## Hyatt Place at Suburban Collection Showplace SP 11-44

Consideration of the request of Cunningham Limp for a recommendation to City Council for Preliminary Site Plan and Stormwater Management Plan approval. The subject property is located north of Grand River Avenue and west of Taft Road at the existing Suburban Collection Showplace site, in Section 16 of the City. The property totals 48.23 acres and the applicant is proposing a 6-story, 128 room hotel.

## PLAN REVIEW CENTER REPORT

**SUBJECT: Hyatt Place Hotel at Suburban Collection Showplace, SP#11-44A,  
Traffic Review of Revised Preliminary Site Plan and Traffic Study**

Mark-Up by  
Birchler Arroyo  
Associates, Inc.

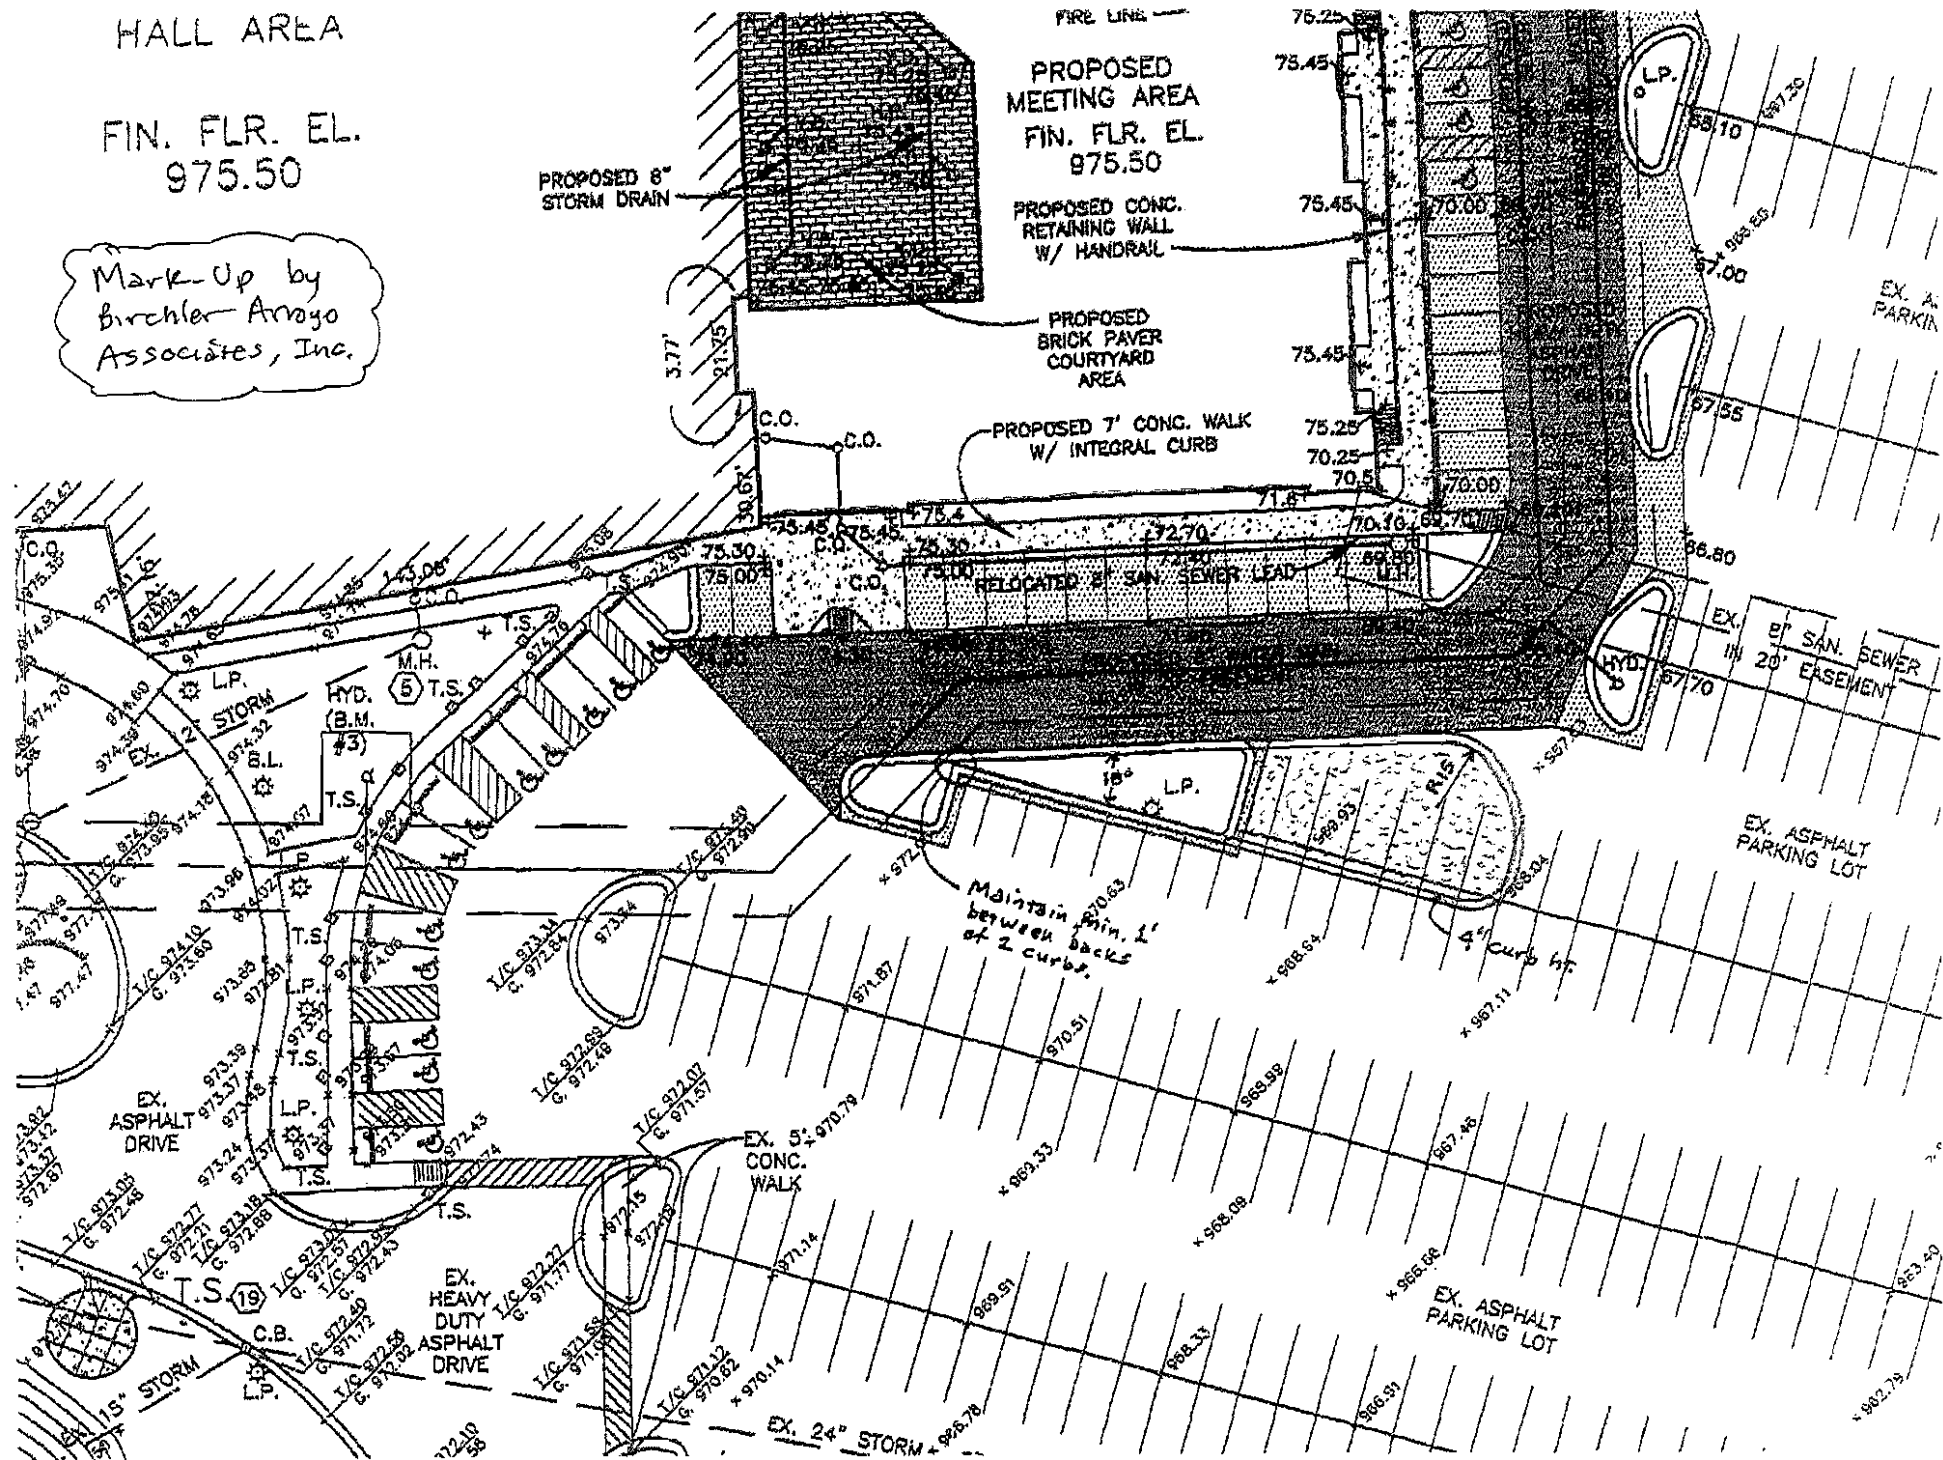
6. Near the southeast corner of the hotel, the existing parking aisle would intersect the new circulation path around the hotel's periphery at a very flat angle (about 18 degrees). We have several concerns over this issue, as we indicated in our pre-application review comments:

- a. Drivers westbound in the parking aisle will find it difficult to know where the safe stopping location might be, given that 7-8 parking spaces would be accessible along the south side of the aisle west of that location.

- b. Vehicles backing out of those 7-8 spaces would be distracting to pedestrians and other drivers, particularly those circulating in either direction around the hotel. Also, those backing drivers may not be able to see or anticipate such circulating traffic.

**We strongly recommend that the above concerns be mitigated by extending the island as shown in our attached mark-up of the pre-application site plan. This concern is the reason we are recommending against approval of the preliminary site plan.**

**#4 – Traffic Circulation.** The applicant intends to revise its plan in part to respond to the Traffic Consultant's letter relating to circulation. We will be installing the no right turn sign and are proposing the installation of stop signs at the pedestrian crossing and at the island south of the proposed fire hydrant in order to eliminate safety concerns contained in Birchler Arroyo's letter.
